BOSTON EDISON

Pilgrim Nuclear Power Station
Rocky Hill Road
Plymouth, Massachusetts 02360

October 13, 1994
BEC0 Ltr. #94-110

Pilgrim Shroud Analysis

Figure 1: Shear Force vs. Elevation for Pile/Bien Blowedown Analysis

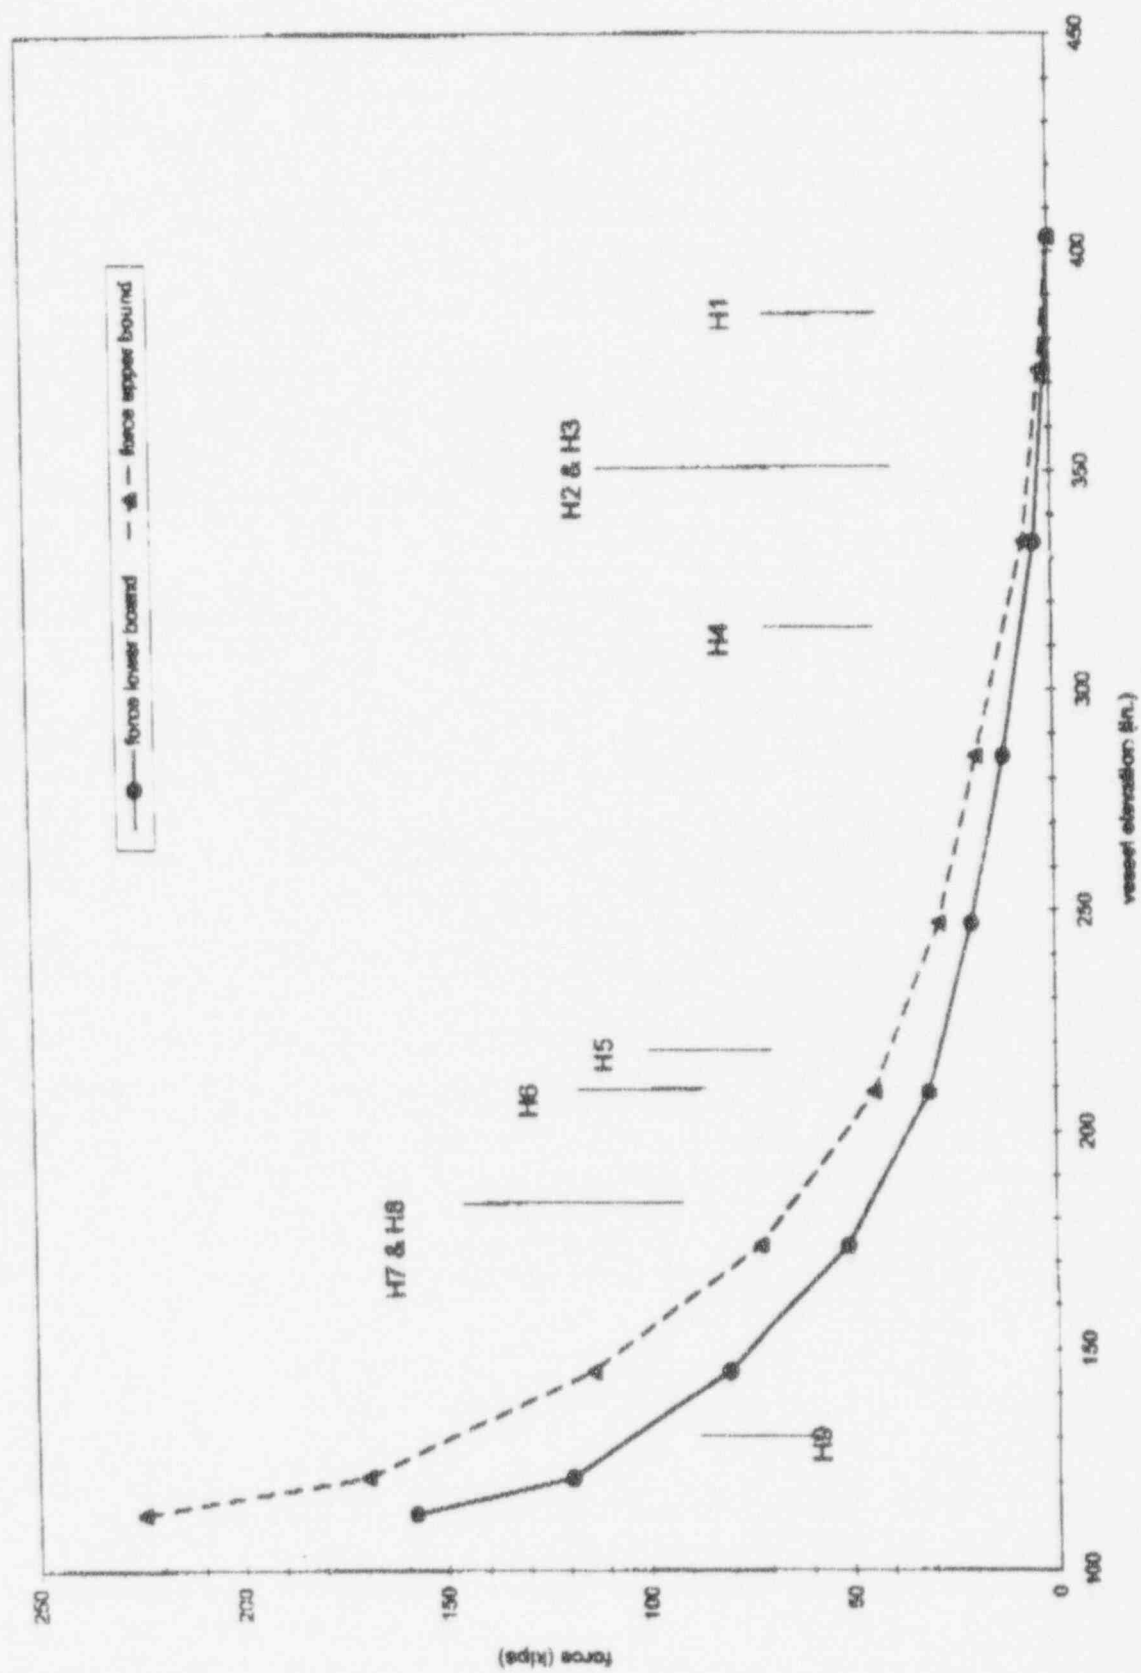
Question 2: Provide the specific assumptions used for the PNPS TRACG analysis of the downcomer region and any benchmarking that has been performed on this model. (Confirm that the TRACG plant specific loads were the basis for the determination of the shroud response to the Recirculation Line Break).

The blowdown load for PNPS was calculated as stated in section 3.1.3.2, page 33 of reference 1. A TRACG Recirculation Line Break analysis was done for a large jet pump BWR plant (reference 2). The detailed modeling and benchmarking of this analysis is found in reference 2. The resulting TRACG blowdown pressure distribution around the shroud was used to calculate the lateral force and tipping moment as a function of shroud elevation for this case. The specific PNPS results are derived as follows:

- The fluid velocity distribution around the shroud, normalized to the blowdown flow and downcomer volume, is the same for PNPS as for the referenced TRACG calculation.
- The pressure distribution around the shroud is determined using the fluid velocity profile.
- The shroud lateral force is calculated using the shroud area corresponding to PNPS.
- The shroud moment is calculated for each elevation by integrating the forces above each elevation.

The blowdown flow rate for both PNPS and the referenced calculation is the same. The shroud area and annulus gap for PNPS are 90% and 91% of the referenced calculation. The resulting force and moment at the limiting H7 weld location (highest tipping displacement) for PNPS are slightly smaller when compared against those from the reference calculation. This smaller force is the result of a smaller shroud area in PNPS compared to the large BWR. The attached figures 1 and 2 show the results of the PNPS RLB analysis as a function of shroud elevation.

Figure 3-1. PLEDGE Model Benchmarked to Brunswick 1 H3 Cracking

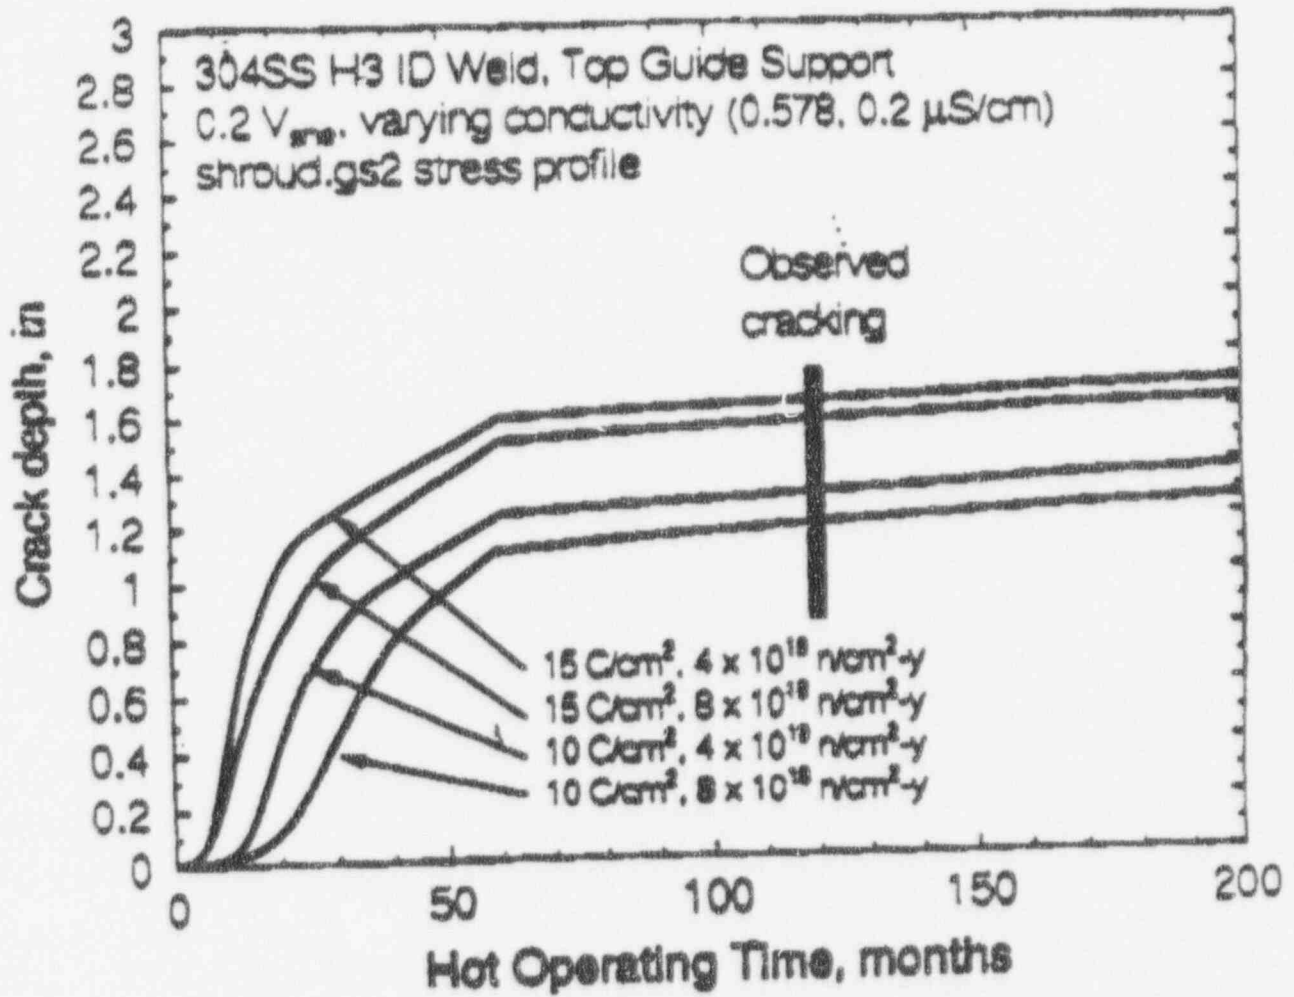
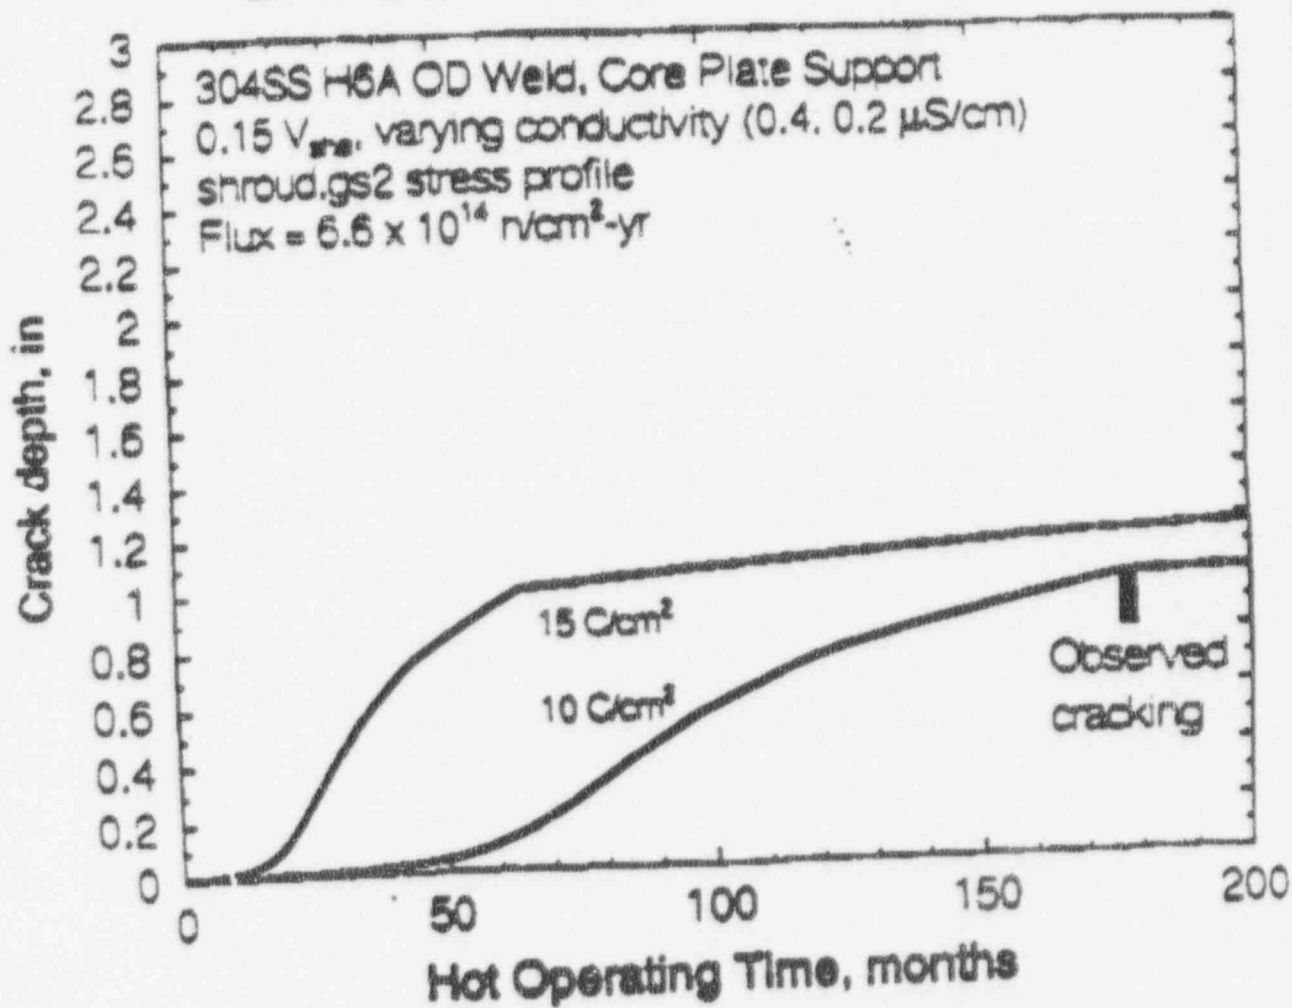
Question 3: Provide any data that supports the statement in section 2.6 that the PLEDGE model has been benchmarked with the Brunswick depth measurements.

- A residual stress profile developed from finite element analysis of the shell-to-ring geometry was scaled such that PLEDGE model results for the Brunswick 1 chemistry history would reasonably predict the cracking found at H3. Figure 3-1 from Reference 3, attached, shows the results of the Brunswick benchmarking analysis where variations in material sensitization and fluence have been considered as well. It should be noted that Figure 3-1 shows the range of cracking found at the Brunswick H3 weld. The average crack depth, which would correspond to the 360° cracking case depicted by PLEDGE, was about 1.4 inches.
